Modification of Development Consent

Section 4.55(1A) of the *Environmental Planning and Assessment Act 1979*

Modification 7

- Modification Application:** SSD-5248-MOD-7
- Applicant:** Gazcorp Pty Ltd
- Consent Authority:** Minister for Planning and Public Spaces

Figure 1: Concept Layout – MOD-7

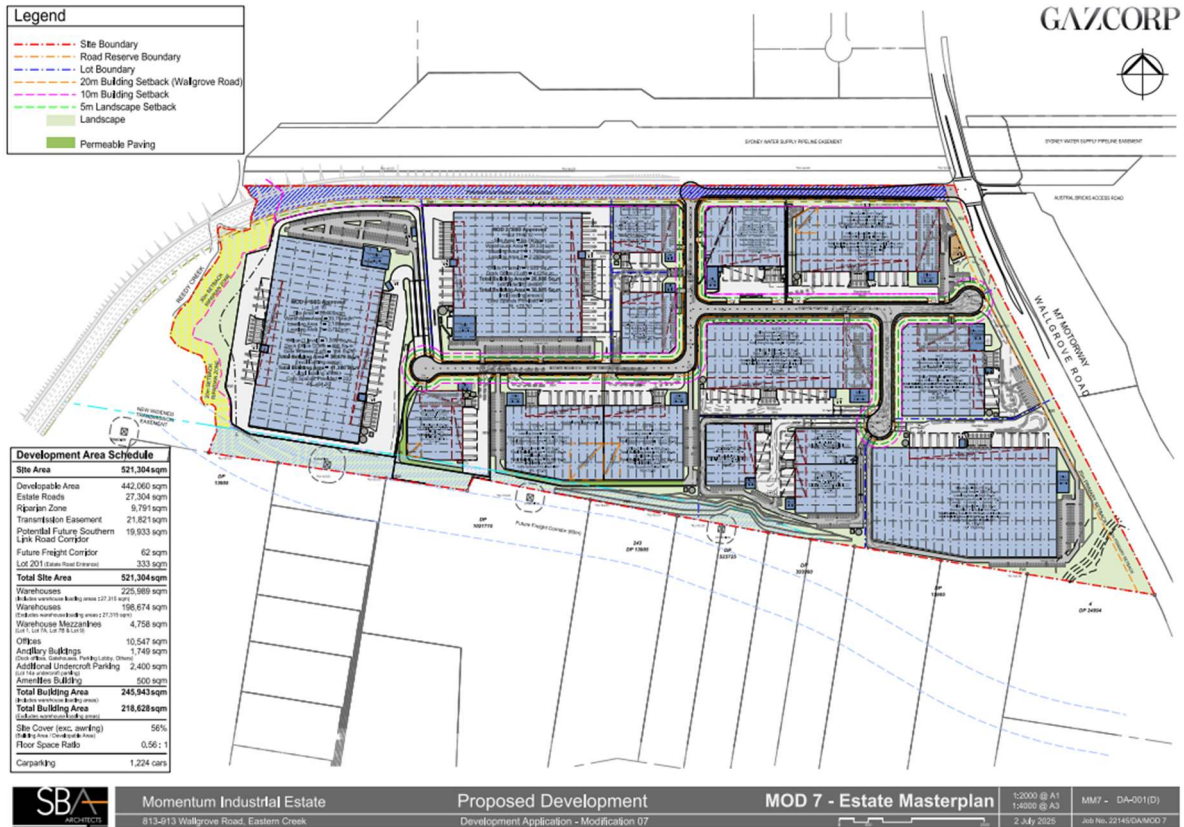
13. Delete Figure 1 and replace with the following:

Modification: Modification to the Concept Plan including:

- increase in warehouse buildings from 11 to 13
- adjustments to lot layouts
- Modification to the Stage 1 including:
 - revised cut and fill for new building levels
 - revised road layout to eastern sections of internal estate road
